Re: Kargaburun Mast investigation

2.1 TECHNICAL REPORT ON THE STRUCTURAL COLLAPSE

SITE: LORSTA Kargaburun (7990 Yankee)
Turkish Army Depot
Marmara Sea
TURKEY

STRUCTURE: 625' LORAN C Mast; Navigation Beacon.
Triangular 5' Face Mast (Tube Construction)
Messrs. Stainless Inc. PENNSYLVANIA USA

FIG. 1 - 625 FT LORAN "C" MAST KARGABURAN, TURKEY

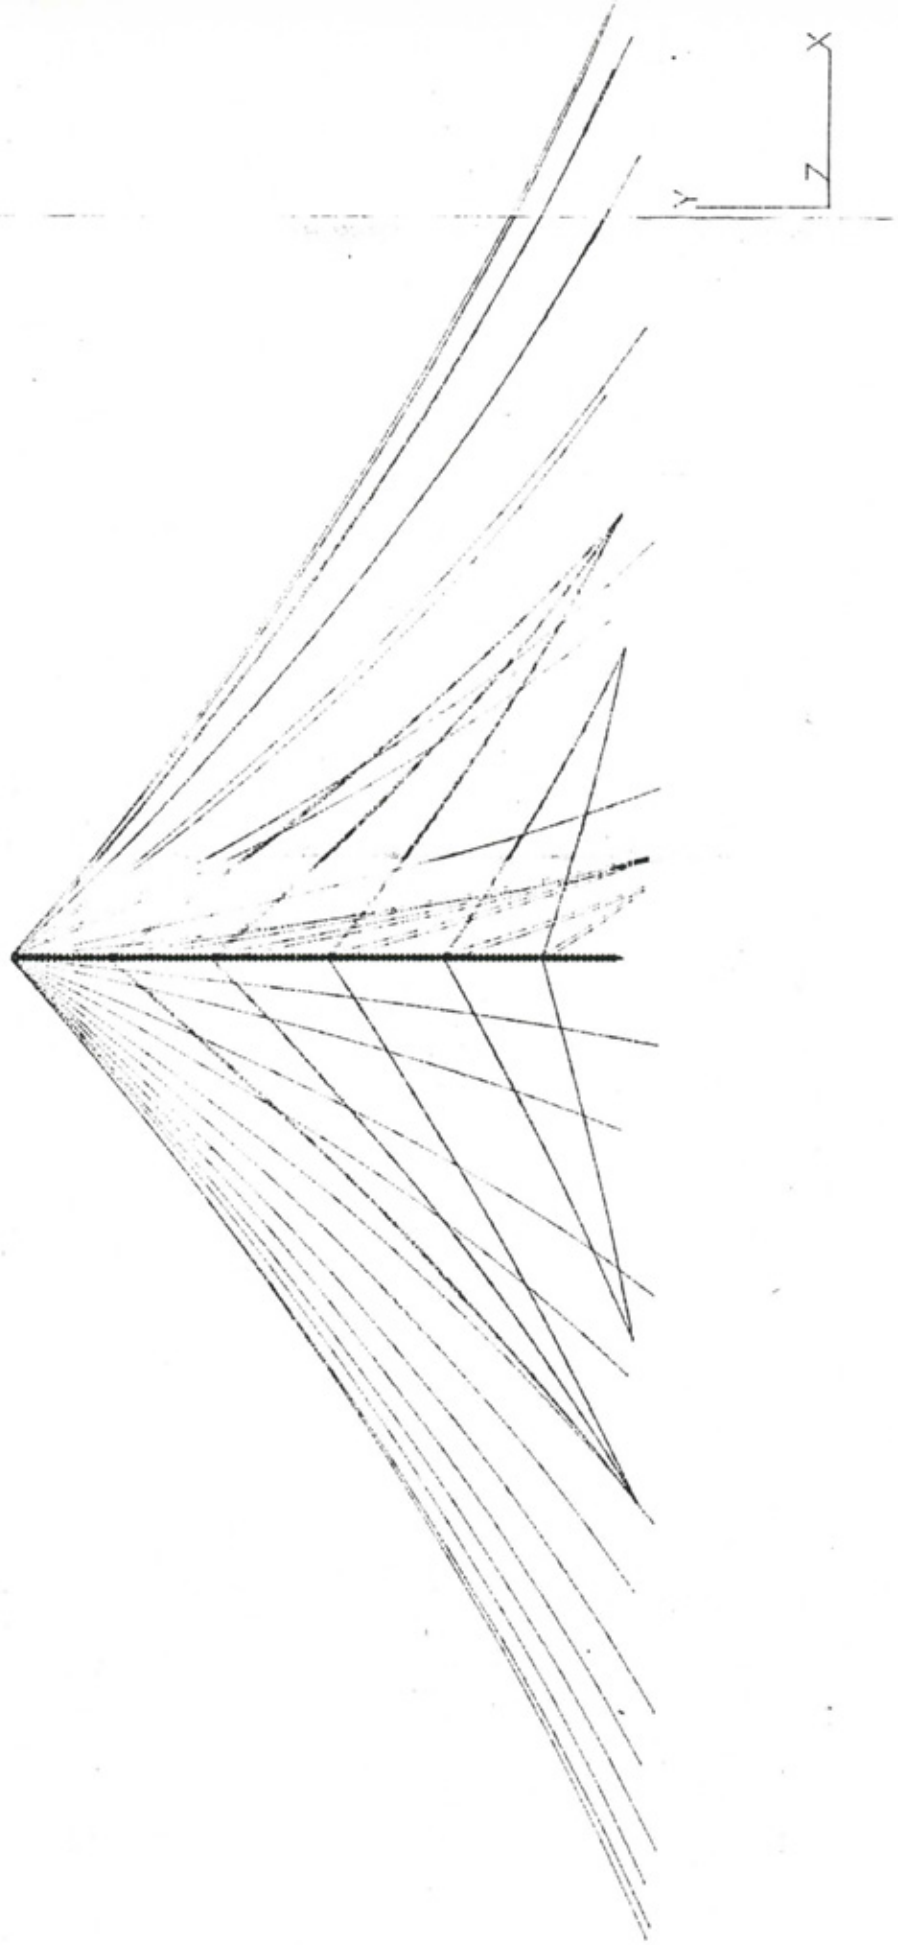
Analysis of the tower for initial pretensions under calm conditions shows that the tower was twisted and "out of plumb" prior to the collapse. The results of the analysis are summarised in table 1. The calculated vertical mast load at the base under initial conditions is 81,000 lbs.

X I do not concur.

FIG. 2 - TOP DISPLACEMENTS @ INITIAL CONDITIONS

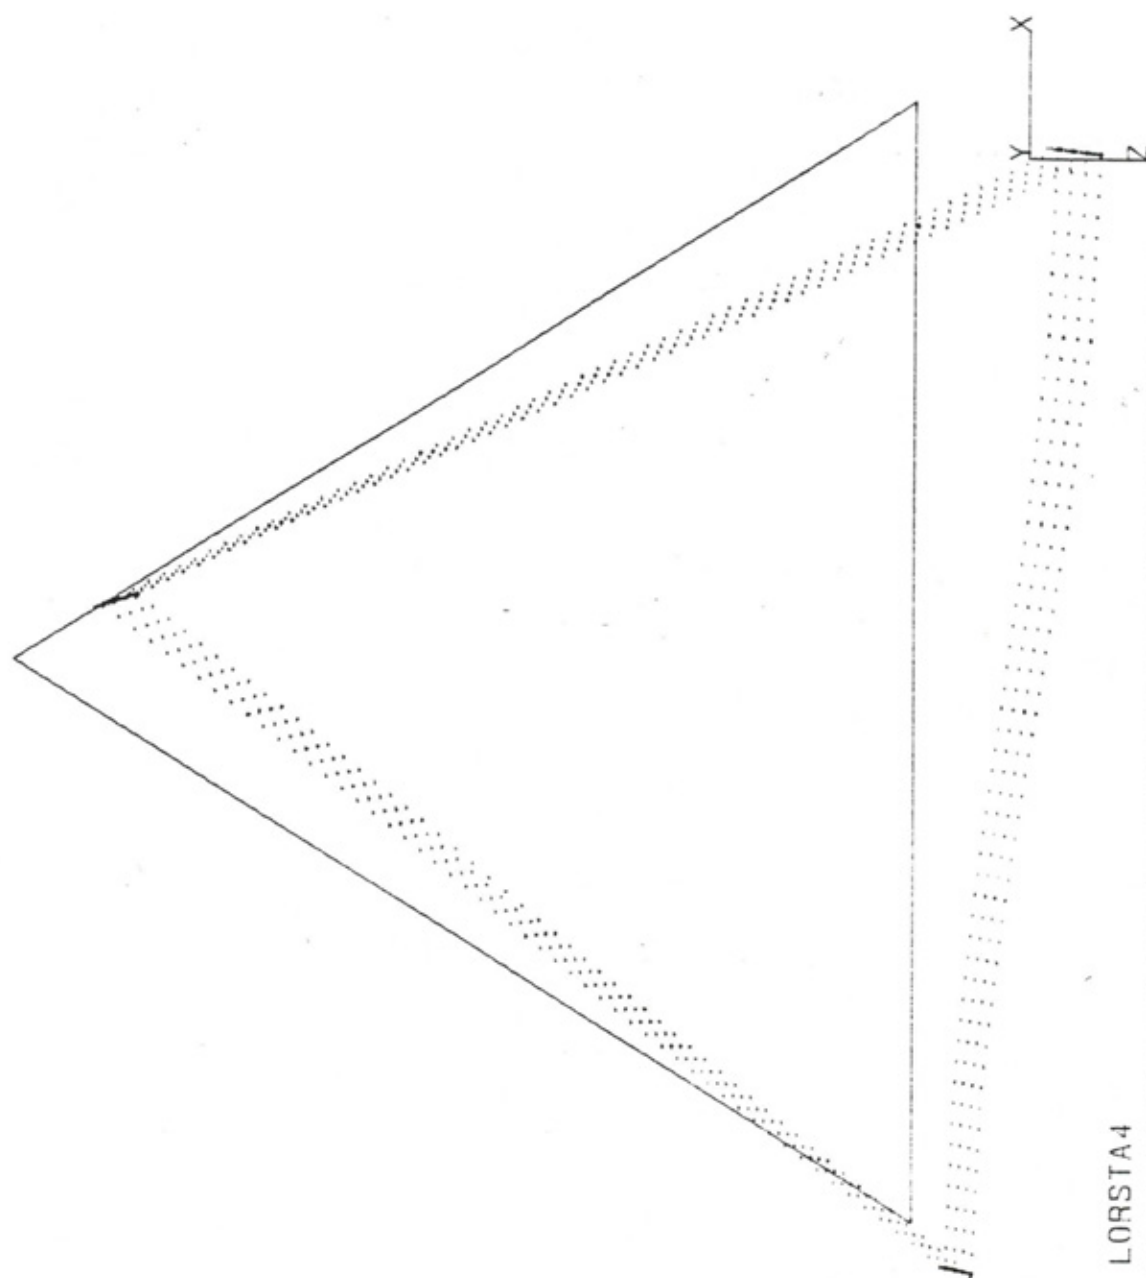
Fatal Flaw
in analysis

FIG 2 shows a view of the upper section of the tower. The displaced shape is shown dashed and clearly shows the initial displacements and twist.
